**Subject:** L0900002-v1: VRB request: all SmCo magnets UHV compatible?

LIGO-L0900002-v1

Vacuum Review Board:

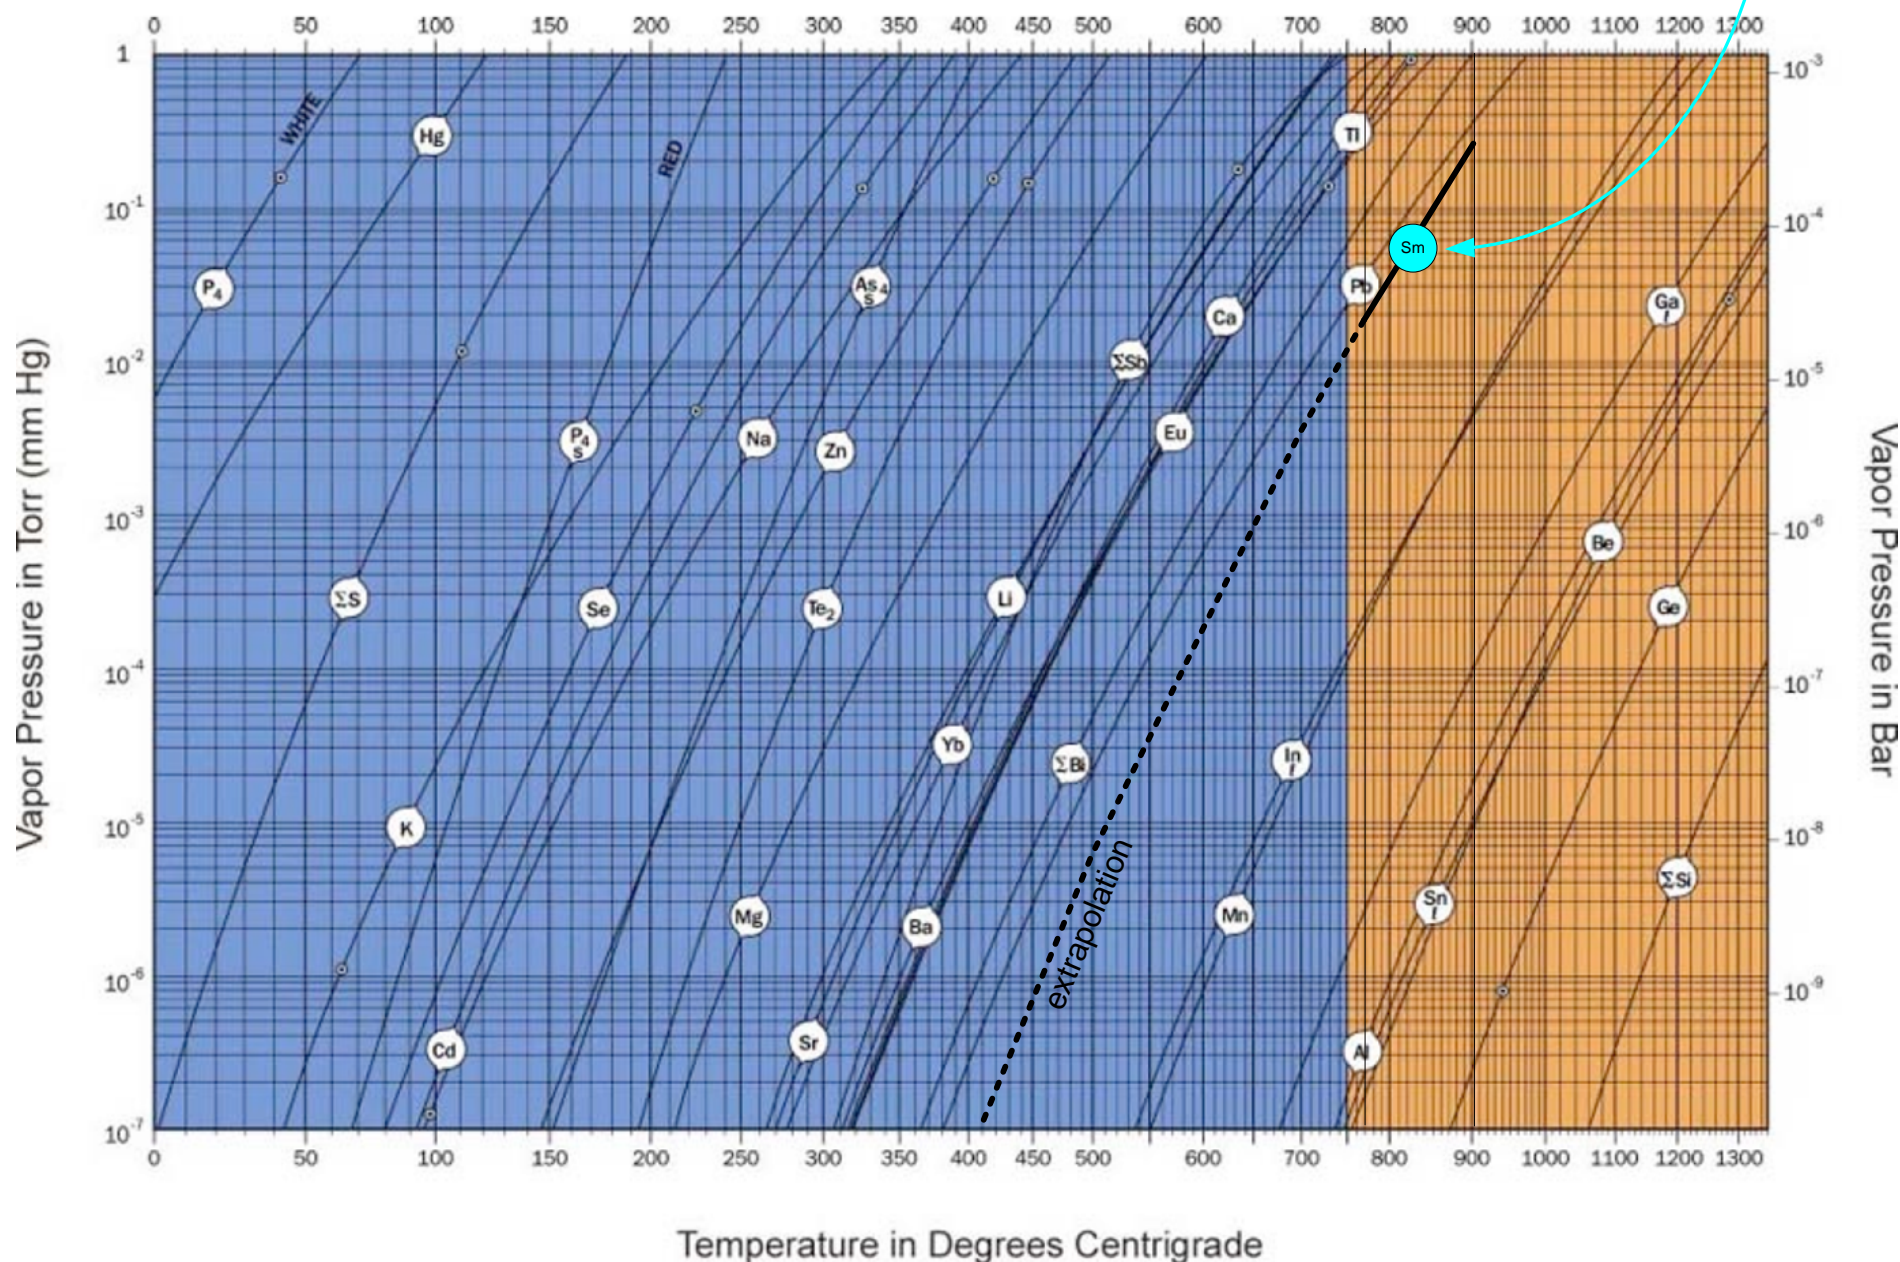
I write to petition that all forms and sources of SmCo be accepted as inherently vacuum compatible materials since the vapor pressure of both Sm and Co is exceedingly low (see attached annotated vapor pressure chart). Do you concur?
